#### CITY OF WINTER PARK PLANNING AND ZONING BOARD

#### Staff Report October 2, 2018

SPR 18-10 REQUEST OF GIOVANNI FERNANDEZ AND ELISE SABATINO FOR: APPROVAL TO CONSTRUCT A 5,624-SQUARE FOOT ADDITION AND TO RELOCATE THEIR SWIMMING POOL AND DECK TO THE REAR OF THEIR PROPERTY LOCATED AT 181 VIRGINIA DRIVE ON LAKE VIRGINIA, ZONED R-1AAA.

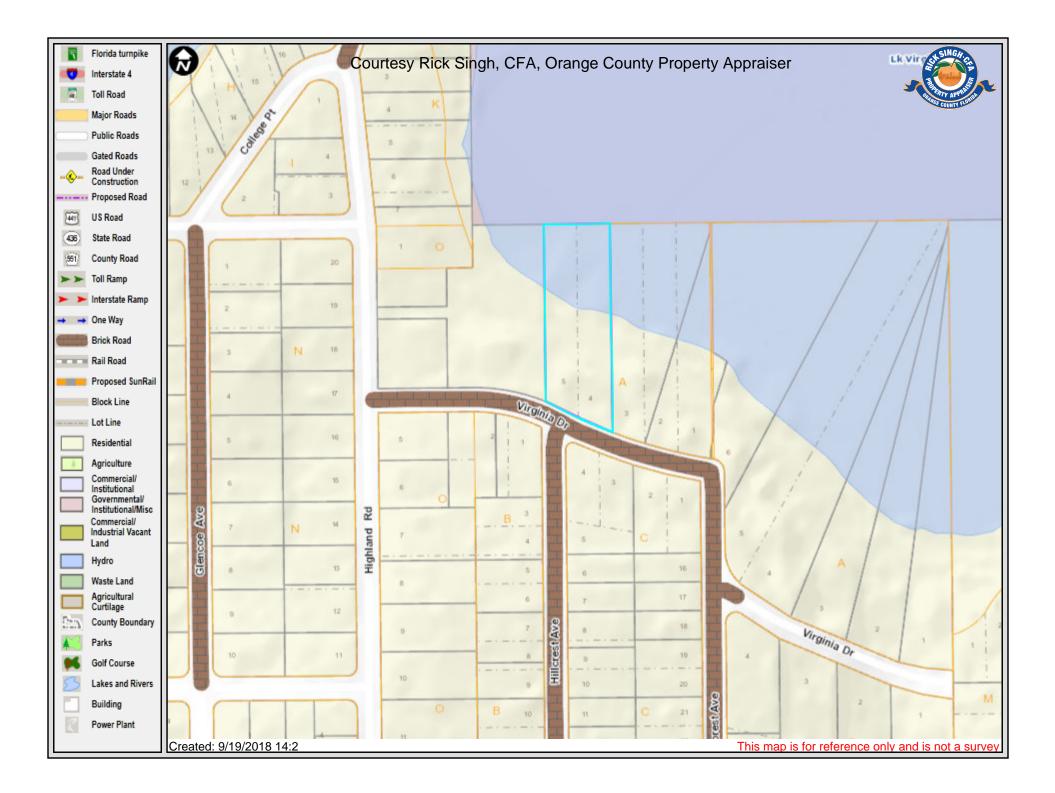
**VIEW FROM THE LAKE:** The Code direction is to minimize the height and extent of stem walls or retaining walls facing the lake. Generally, the policy is not to permit walls/swimming pool decks facing the lake in excess of three feet in height. This lot has a significant grade drop of over ten feet from front of the house to the lakeside of the swimming pool. Therefore, managing that grade drop throughout the length of the home and on the side yards took careful planning. Due to this, there are several steps down from the home to the pool deck as to not exceed the three foot height rule.

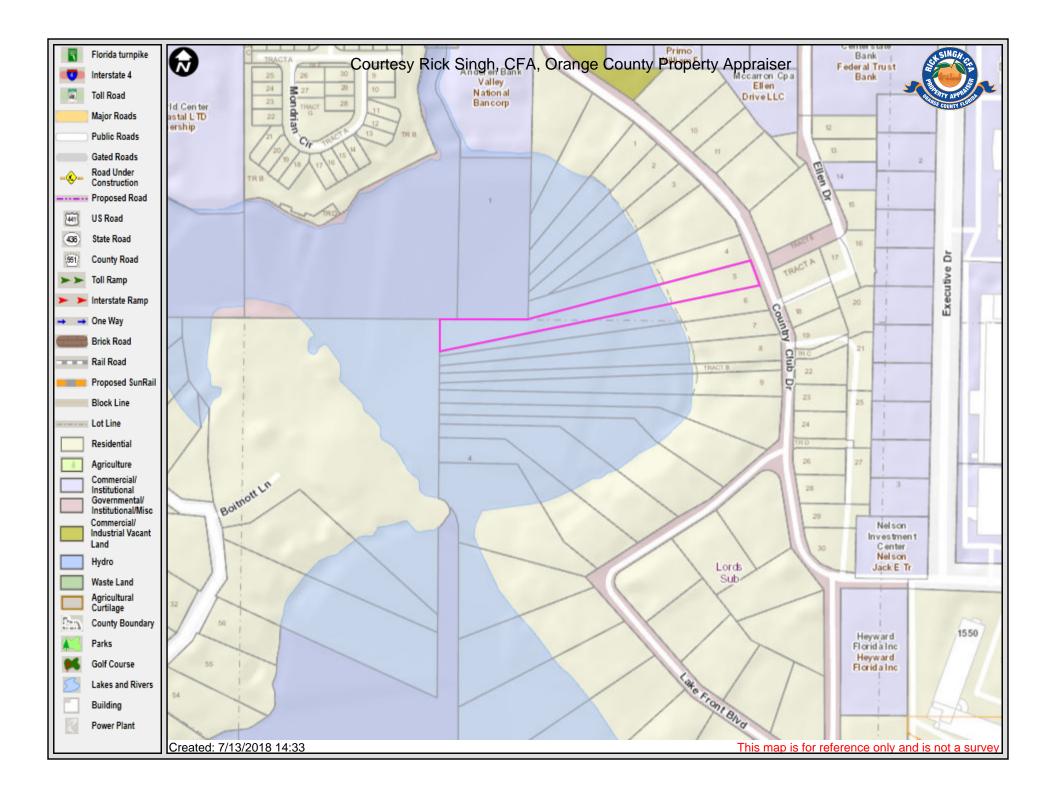
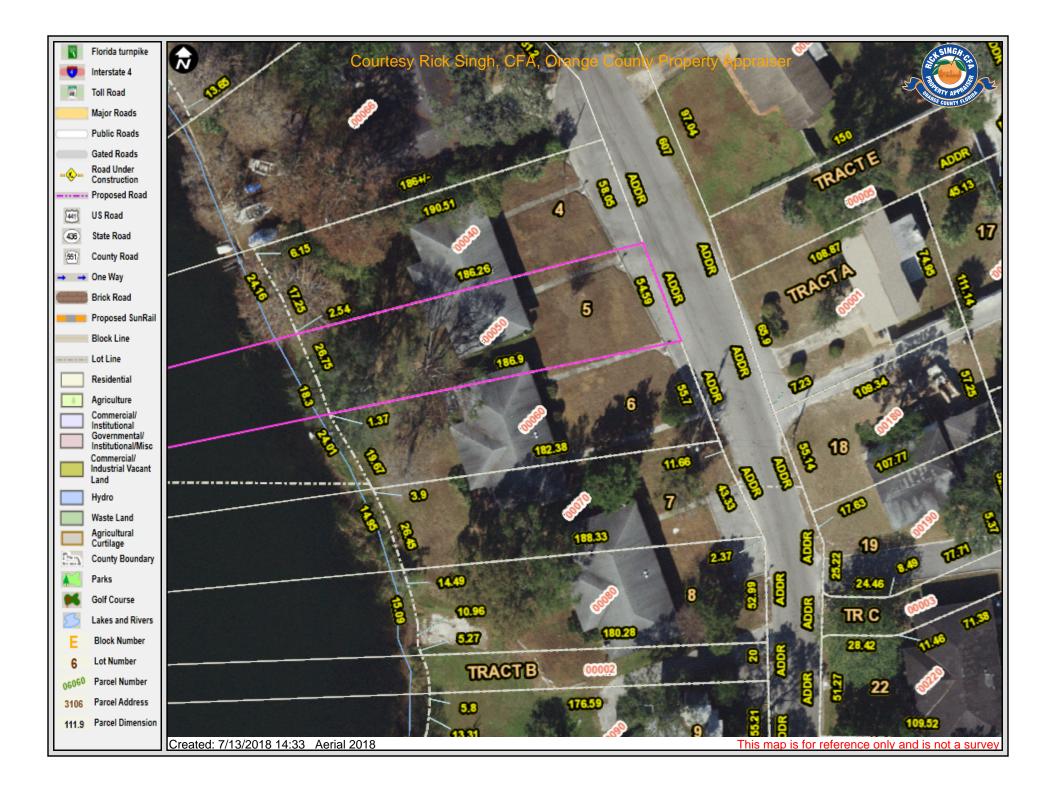
Staff has determined that the average lakefront setback is 76.2 feet from the normal high water elevation (see attached analysis). Per the developer's calculations, they have an average setback of 75.8 feet. In both scenarios, the proposed lakefront setback is closer to the lake than what is established by the average lakefront calculations.

This applicant/builder is proposing a 70 foot setback from the lake to the home, and a 50 foot setback to the pool deck. While, the Code defines structures to include swimming pools and pool decks, the swimming pool/deck being at the existing grade does not impair lakefront views. However, the two-story home can impact lake views and therefore, the applicant is requesting a lakefront setback variance of 6.2 feet from the City's calculations.

The applicant has provided a letter signed by the developer/owner of the Lake Killarney replat properties nearest to this lot and also signed by the nearest affected (non-developer owned property) neighbor to this lot (owner of 612 Country Club Drive), that states an agreed-upon building setback of 70 feet from the lake, and pool setback range of the agreed-upon building setback to 50 feet. P&Z has the authority to approve lakefront setbacks less than the average determined by staff above to a minimum of 50 feet, in accordance with their lakefront review authority.

That attached letter will be the basis for the lakefront building setbacks for this as well as the other lakefront lots, as it involves agreement by all affected parties. Staff does not see a major concern with the 6.2 foot building setback variance to allow the building to be 70 feet from the lakefront, given this concurrence.
